PECOS DISTRICT CONDITIONS OF APPROVAL

OPERATOR'S NAME:	Devon Energy Prod Co., L.P.
LEASE NO.:	NM-0405444
WELL NAME & NO.:	Aldabra 26 Federal 7H
SURFACE HOLE FOOTAGE:	330' FSL & 1420' FEL
BOTTOM HOLE FOOTAGE:	2600' FSL & 1000' FEL Sec, 23
SHL LOCATION:	Section 26, T. 23 S., R. 31 E., NMPM
COUNTY:	Eddy County, New Mexico

Cross Section of a Typical Lead-off Ditch

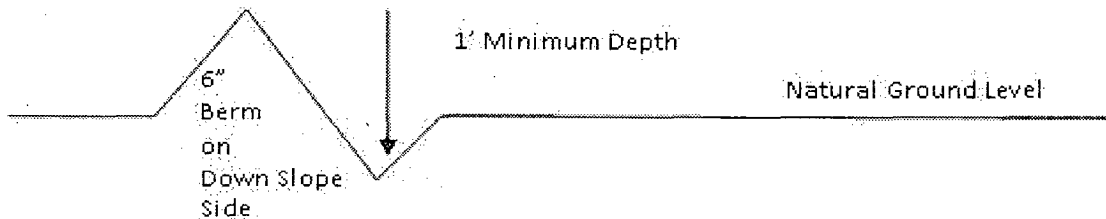
A typical lead-off ditch has a minimum depth of 1 foot below and a berm of 6 inches above natural ground level. The berm shall be on the down-slope side of the lead-off ditch.

All lead-off ditches shall be graded to drain water with a 1 percent minimum to 3 percent maximum ditch slope. The spacing interval are variable for lead-off ditches and shall be determined according to the formula for spacing intervals of lead-off ditches, but may be amended depending upon existing soil types and centerline road slope (in %);

Figure 1 – Cross Sections and Plans For Typical Road Sections

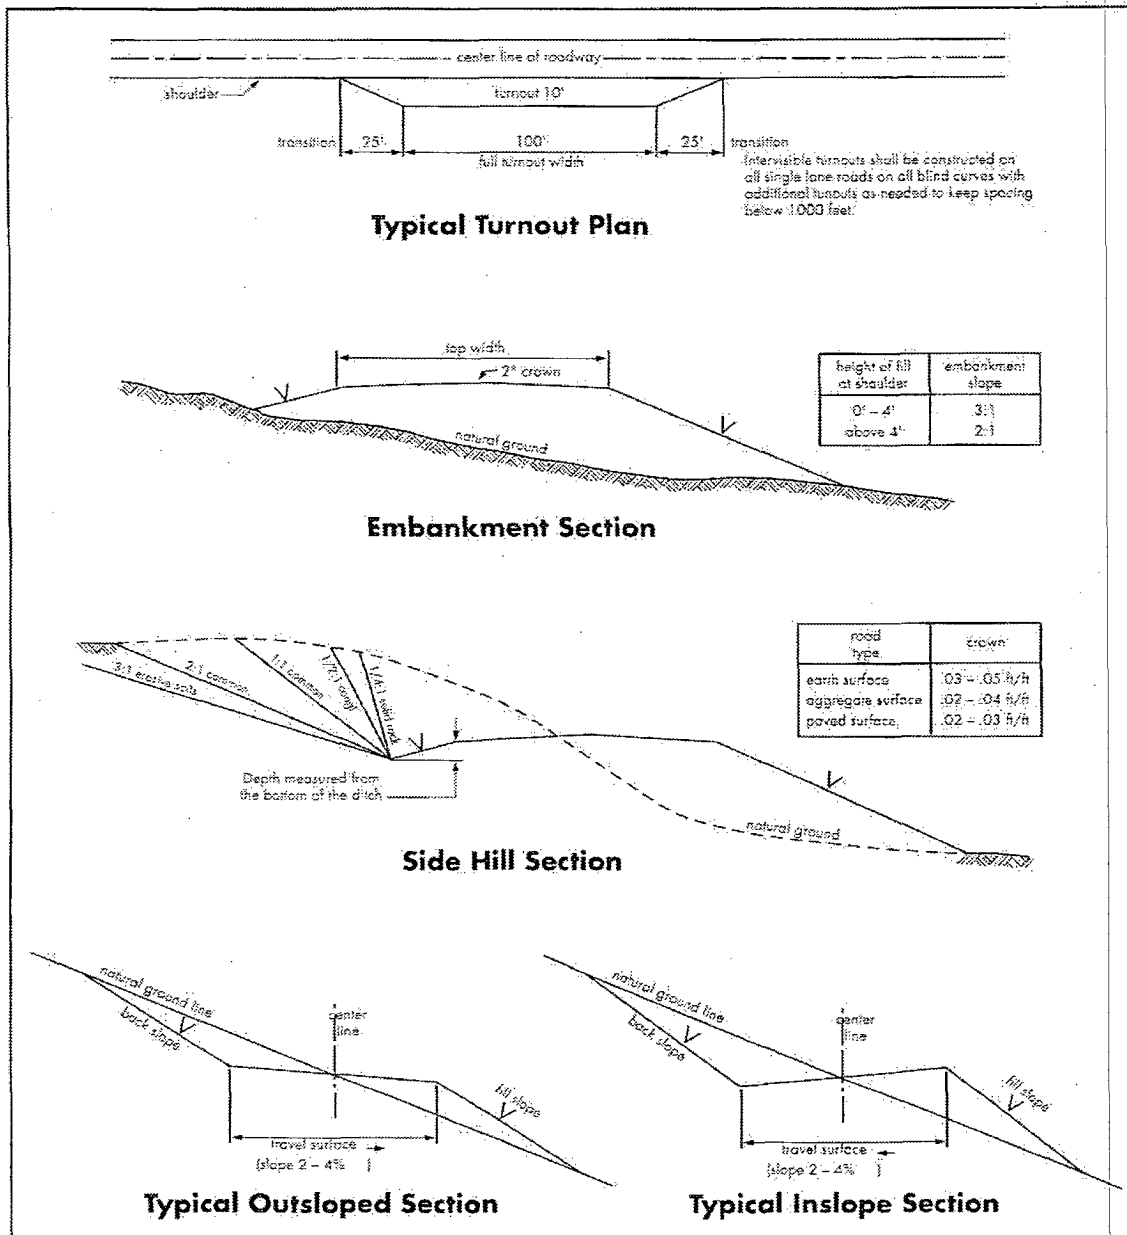
Crowning shall be done on the access road driving surface. The road crown shall have a grade of approximately 2% (i.e., a 1" crown on a 14' wide road). The road shall conform to Figure 1; cross section and plans for typical road construction.
